Project	IEEE 802.16 Broadband Wireless Access Working Group < http://ieee802.org/16 >
Title	Amendment to Subscriber Mode Management in Section 14.2.6
Date Submitted	2006-07-13
Source(s)	Jee Hyeon Na, ETRI, E-mail: jhna@etri.re.kr Yun Won Chung, PhD, Soongsil University, E-mail: ywchung@ssu.ac.kr JungMo Moon, PhD, ETRI, E-mail: jmmoon@etri.re.kr Mi-Young Yoon, ETRI, E-mail: myyun@etri.re.kr Sang Ho Lee, PhD, ETRI, E-mail: leesh@etri.re.kr Young Seok Kim, Samsung, E-mail: stephenk@samsung.com
Re:	Call for Comment on P802.16g Baseline Document
Abstract	This contribution proposes service primitives for accounting.
Purpose	The document should be considered during the resolution of comments on the baseline document.
Notice	This document has been prepared to assist IEEE 802.16. It is offered as a basis for discussion and is not binding on the contributing individual(s) or organization(s). The material in this document is subject to change in form and content after further study. The contributor(s) reserve(s) the right to add, amend or withdraw material contained herein.

Amendment to Subscriber Mode Management in Section 14.2.6

Figure 493 Subscriber mode transition diagrams of MS & BS

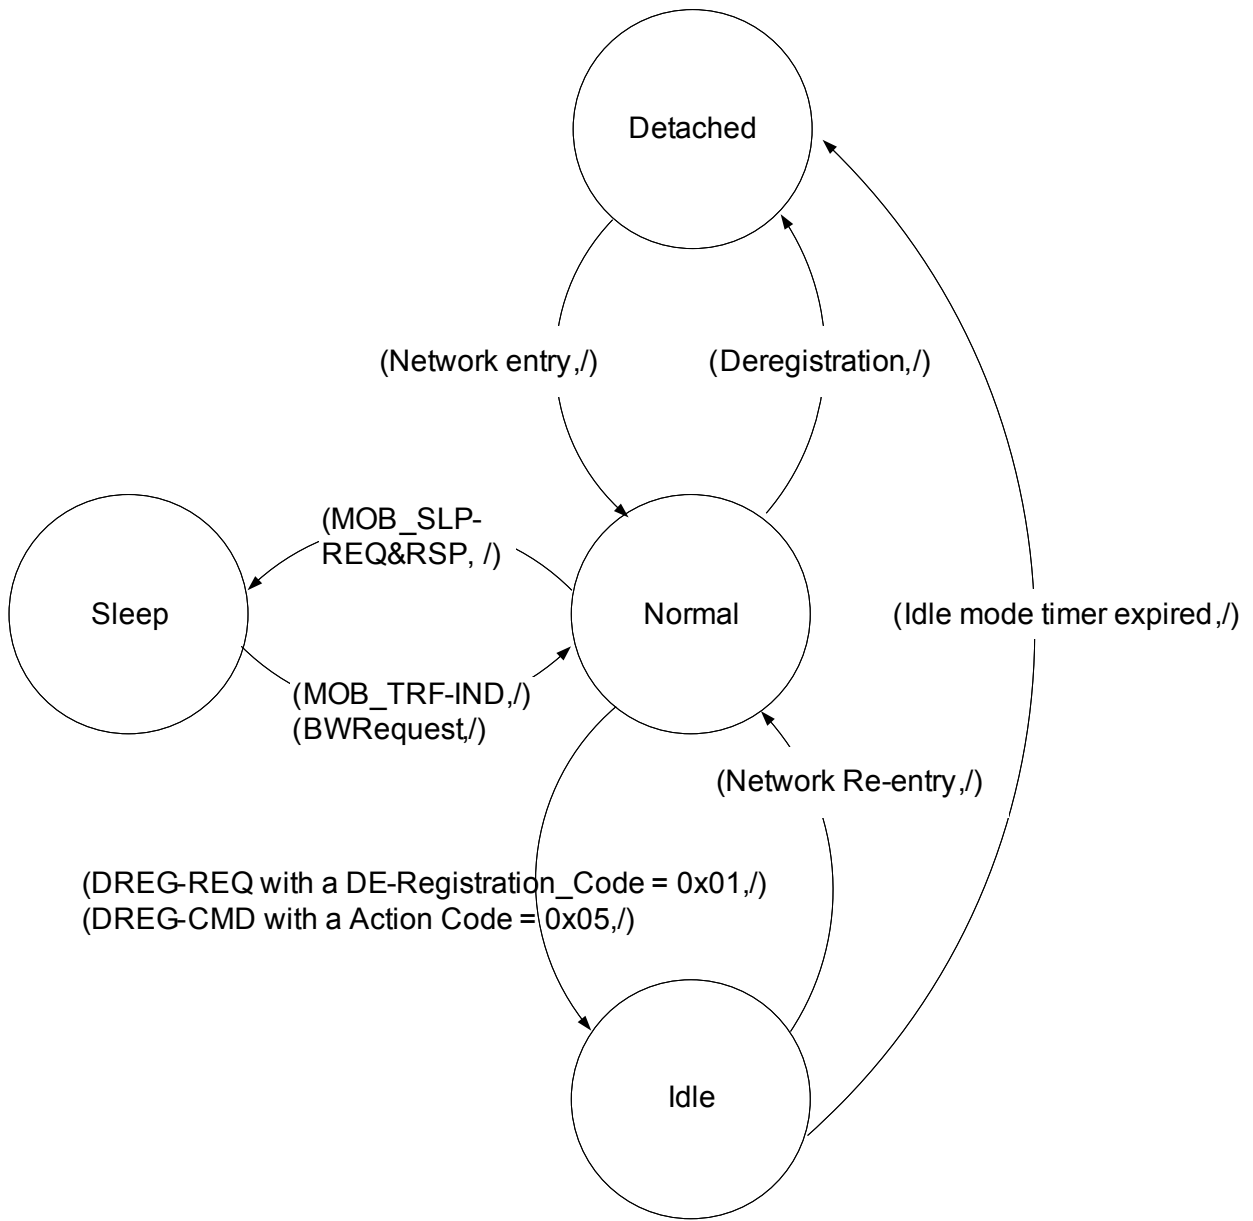
Figure 493 shows Subscriber Mode transition diagram at both an MS and a BS. Initially, the subscriber mode is Detached Mode and the subscriber mode at both an MS and a BS changes from

Detached Mode to Normal Mode after initial network entry procedure. Subscriber Mode ~~at both an MS and a BS~~ changes from Normal ~~Operation Mode~~ to Idle Mode when the MS issues an MS De-registration Request (DREG-REQ) message with `De-Registration_Request_Code=0x01` or the BS issues a De-register Command (DREG-CMD) message with `Action Code = 0x05`. Then, the MS stays at Idle Mode and updates its location when the paging group changes. The Subscriber Mode returns back to Normal ~~Operation Mode~~ from Idle Mode after completing ~~n~~Network re-entry. Transition from Normal ~~Operation Mode~~ to Sleep Mode is performed after an MS successfully exchanges Sleep Request (MOB_SLP-REQ) and Sleep Response (MOB_SLP-RSP) messages with a BS. If there is any DL traffic toward an MS from a BS, MOB_TRF-IND is broadcast to the MS from the BS and Subscriber Mode of the MS and the BS changes from Sleep Mode to Normal ~~Operation Mode~~. If there is any UL traffic from an MS, Bandwidth Request (BW Request) is sent to the serving BS from the MS and Subscriber Mode of the MS and the BS changes from Sleep Mode to Normal ~~Operation~~, too. Transition to Detached Mode from Normal Mode occurs when the MS sends DREG-REQ message without `Deregistration_Code=0x01` or receive DREG-CMD without `Action Code = 0x05`. Transition to Detached Mode from Idle Mode ~~occurs~~ occurs when the Idle Mode Timer of the MS is expired. If MS is switched off in any of Normal, Idle, and Sleep Modes, the state moves to Detached Mode.

Figure 494 Subscriber mode transition diagrams of NCMS

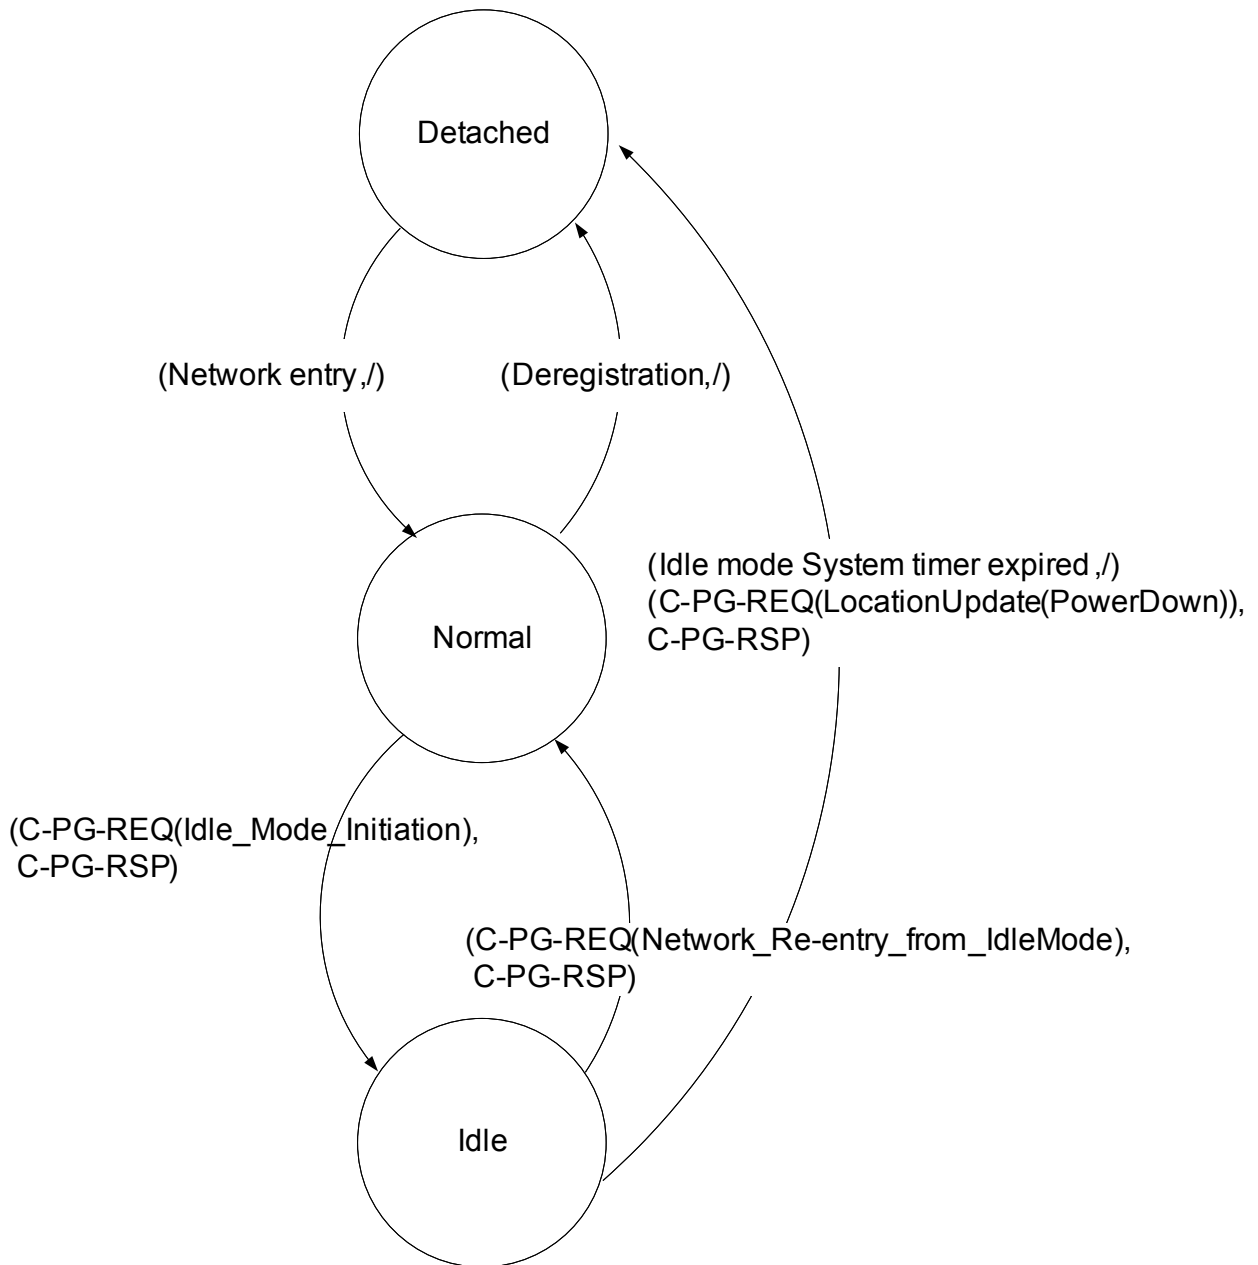
Figure 494 shows Subscriber Mode transition diagram at the NCMS with service primitives related with the Subscriber Mode transition. Initially, the subscriber mode is Detached Mode and the subscriber mode at NCMS changes from Detached Mode to Normal Mode after initial network entry procedure of MS. Subscriber Mode transition from Normal ~~Operation Mode~~ to Idle Mode is performed by exchanging C-PG-REQ and C-PG-RSP between a BS and the NCMS after successful DREG-REQ message with `De-Registration_Request_Code=0x01` or DREG-CMD message with `Action Code = 0x05` between an MS and a BS, where C-PG-REQ and C-PG-RSP are defined in 14.2.6.2.1 and 14.2.6.2.2, respectively. Subscriber Mode transition from Idle Mode to Normal ~~Operation Mode~~ is initiated after exchanging C-PGNOTFY, C-PG-RSP, and C-PG-ACK between a BS and the NCMS, where C-PG-NOTFY, C-PG-RSP, and C-PG-ACK are defined in 14.2.6.2.4, 14.2.6.2.2, and 14.2.6.2.3, respectively. Transition to Detached Mode from Normal Mode occurs by exchanging C-PG-REQ and C-PG-RSP between a BS and the NCMS after successful DREG-REQ message without `De-Registration_Request_Code=0x01` or DREG-CMD message without `Action Code = 0x05` between an MS and a BS. Transition to Detached Mode from Idle Mode occurs when the Idle Mode System Timer is expired. If MS is switched off in either Normal or Idle Mode, the state moves to Detached Mode.
